HISTORIC PRESERVATION COMMISSION

STAFF REPORT Department of Growth Management

| PROJECT: | Lot 20B, (32 Dr. Mellichamp) Calhoun Street Promenade – New Construction |

1. **COFA-2-16-9490.** A Certificate of Appropriateness to construct a mixed use building of approximately 2,075 SF on the property identified as 32 Dr. Mellichamp (Lot 20B in the Calhoun Street Promenade) in the Old Town Historic District and zoned as Neighborhood Core-HD.

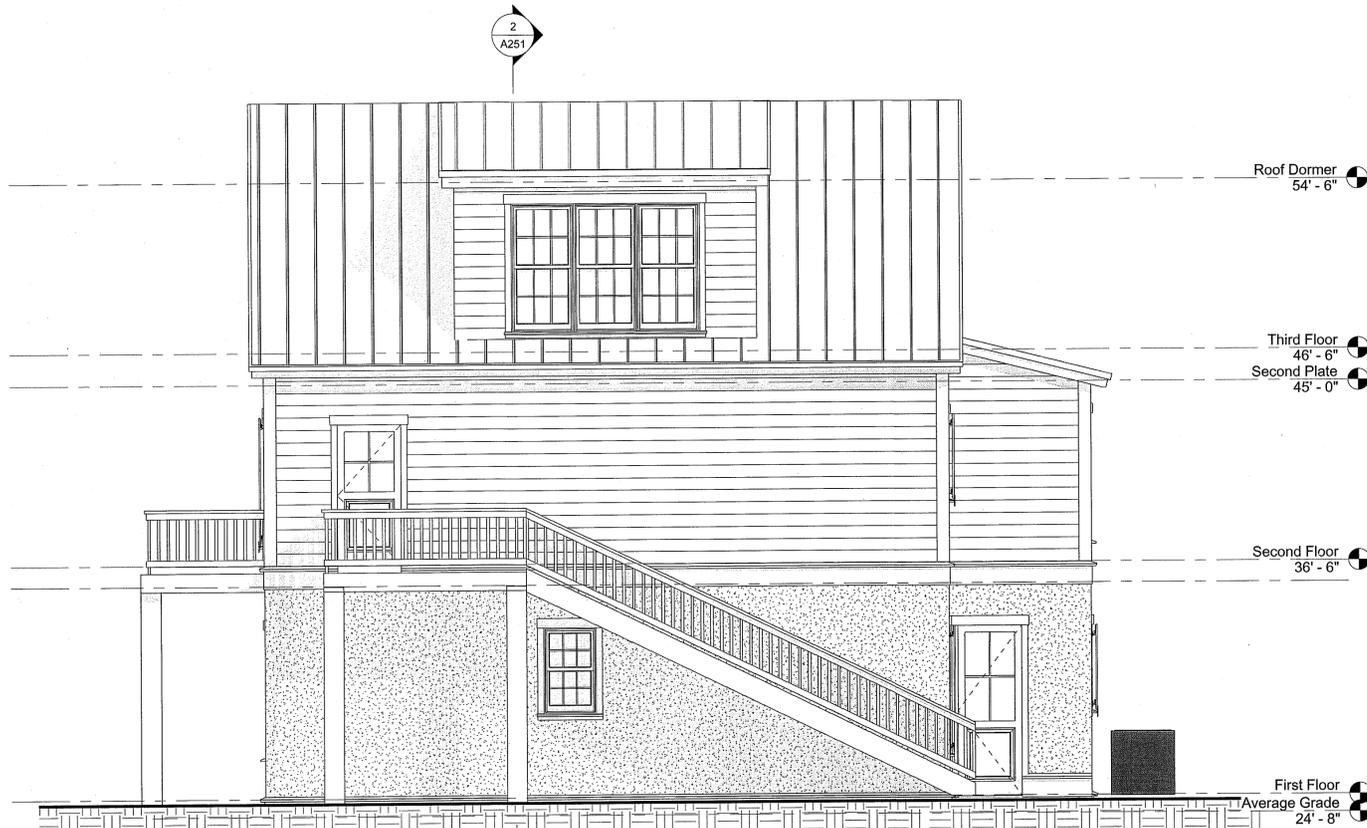
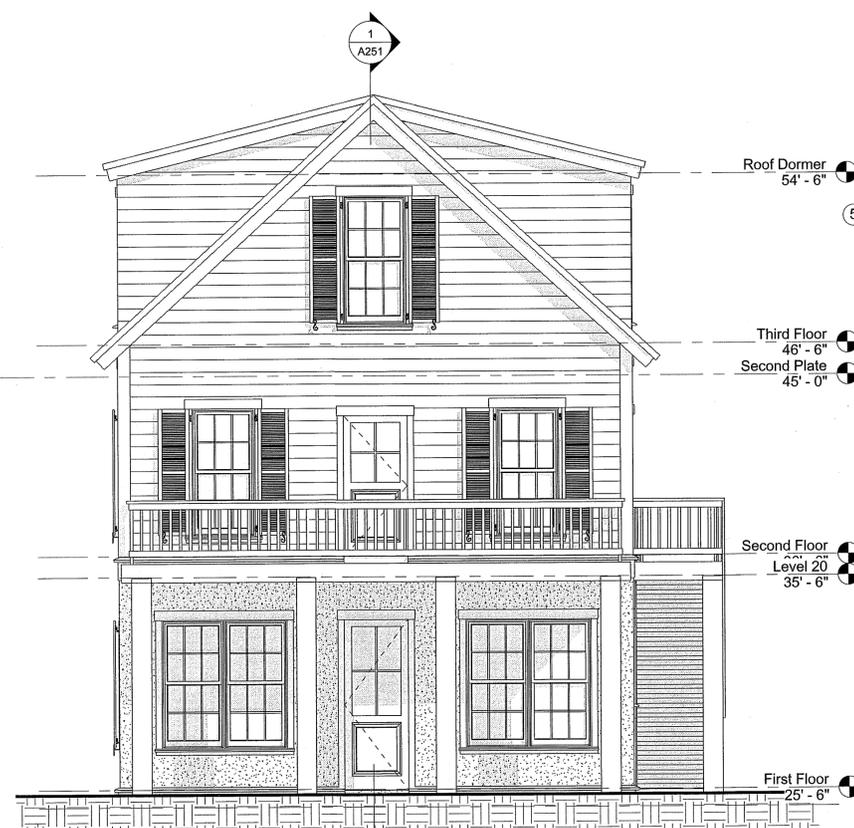
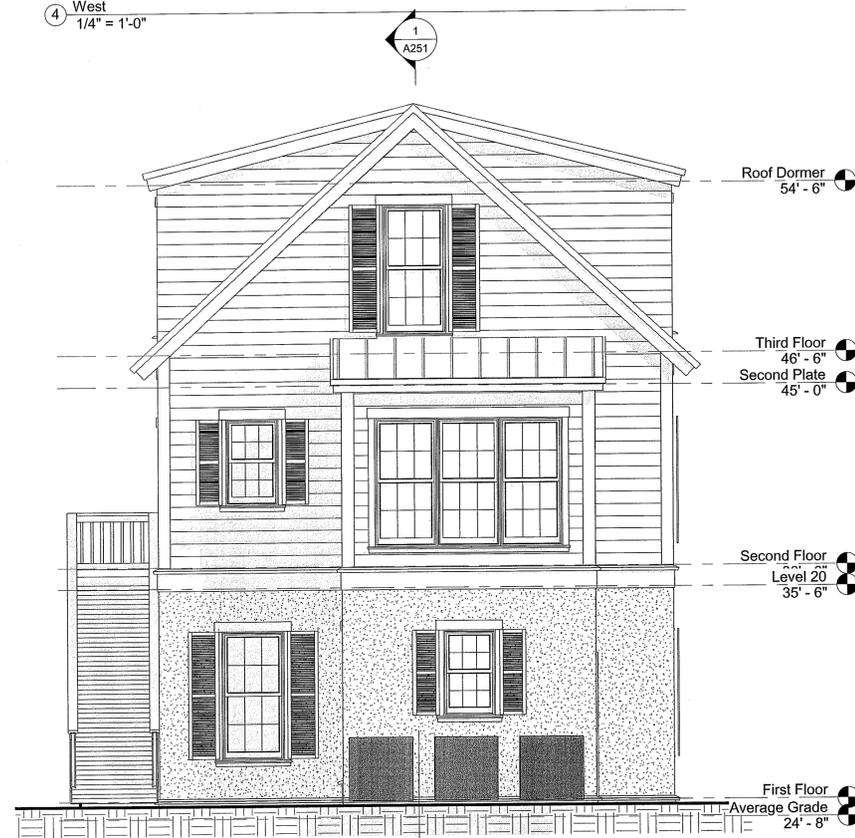
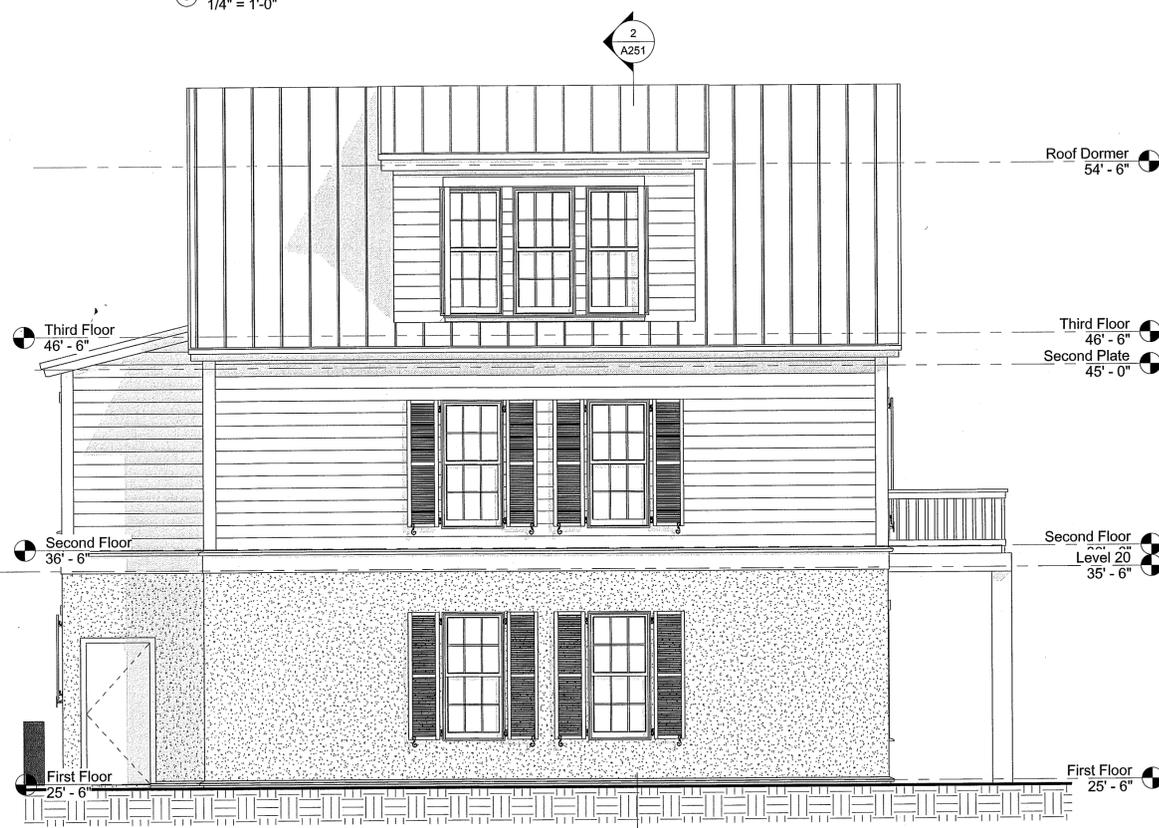
| Submission #: | Received: | Completed: | | |
|--|----------------------|-----------------|--------------------------|--|
| 2. The UDO requires that windows or vents shall occupy the majority of the dormer's surface area. The proposed 3rd floor dormer does not meet this requirement and additional windows would need to be added to satisfy the prerequisite. (UDO Section 5.15.6.E.7) | | | | |

2 Typ. Section
1/2" = 1'-0"

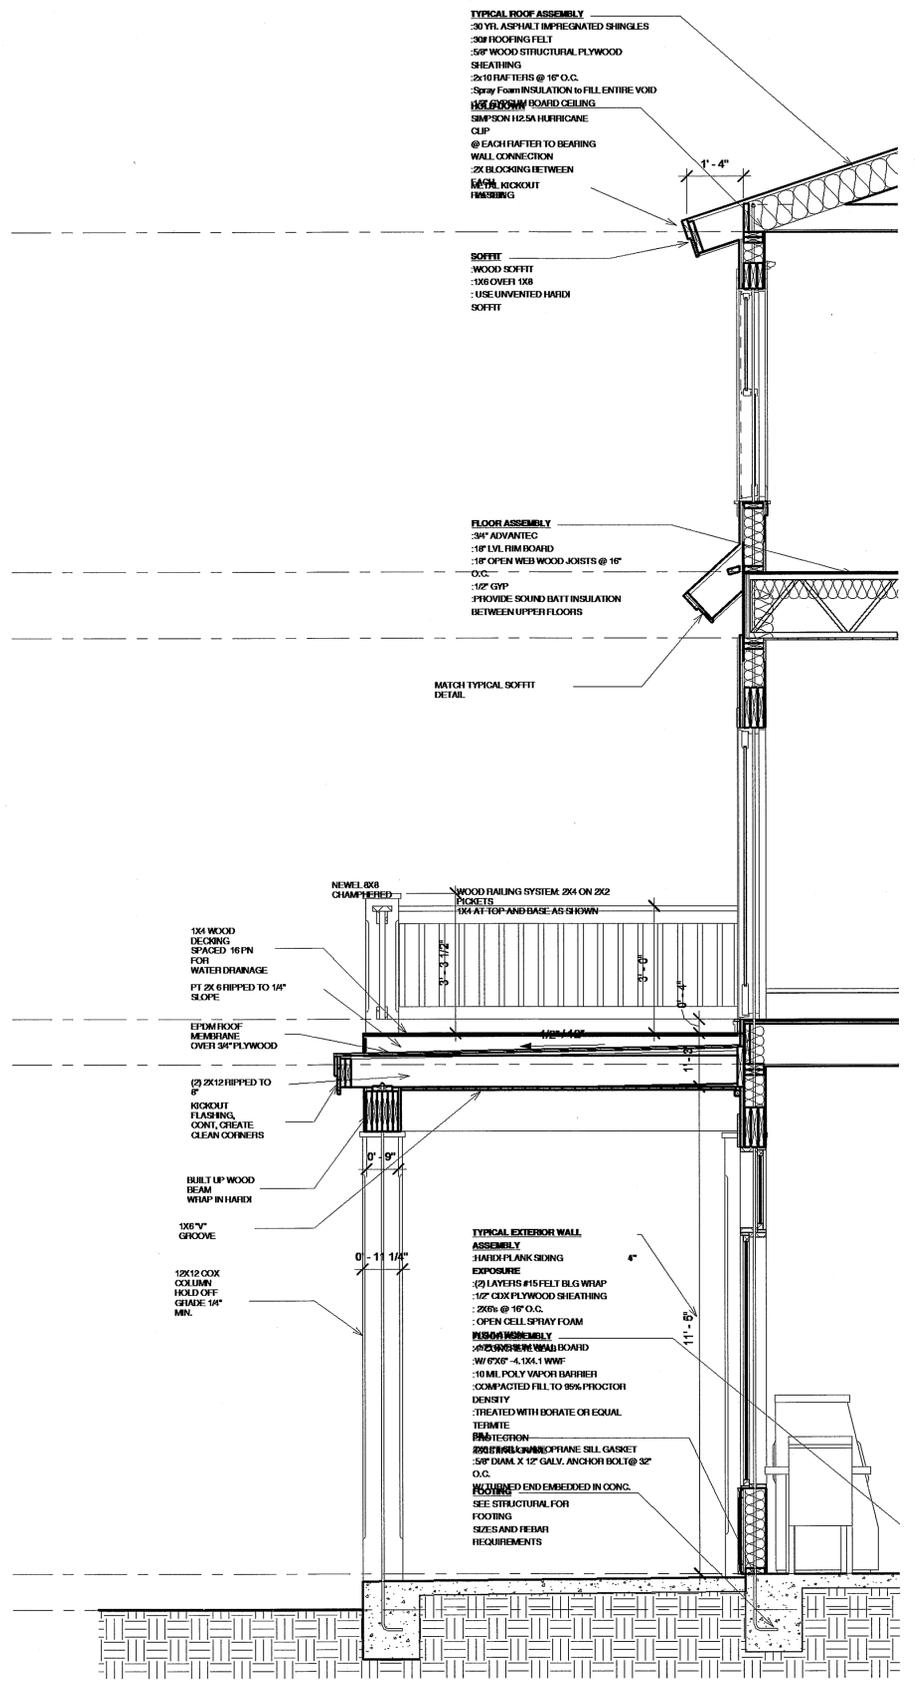
- 2) Per Section 5.15.6.E.3. Colonnades/Arcades. The UDO states that the minimum depth of a colonnade is 8' from the build to line to the inside column face. The proposed colonnade is shown as 5' on the floor plans and elevations, but as 8' on the building section noted as detail 2 on sheet A301. The drawings must be revised to meet the minimum dimensional requirements for a colonnade to meet the requirements of the UDO.

- 3) Per Section 5.15.6.G. Building Walls. The UDO permits the use of stucco over concrete masonry units or reinforced concrete. The elevations and project analysis note the use of stucco on the first floor, but the building section noted as detail 2 on sheet A301 notes the construction of the first floor as typical wood stud framing with hardi-plank siding. This information is inconsistent and the wall detail must be updated to correlate with the elevations and be comprised of a permitted construction method for the use of stucco as a finish material to meet the requirements of the UDO.

- 5) Per Section 5.15.6.J. Roofs and Gutters. The UDO allows metal roofing, 5-V crimp or standing seam, and also allows for asphalt shingles. From the materials provided it is unclear what roofing material is proposed. The project analysis says metal and the drawing depict metal, but the building section notes asphalt shingle. The drawings/project information must be revised to clearly depict an allowable roofing material.

4. Per Section 5.15.6.G. of the UDO, the building section noted as detail 2 on sheet A301 must be updated to correlate with the elevations and be comprised of a permitted construction method (CMU or reinforced concrete) for the use of stucco as a finish material.
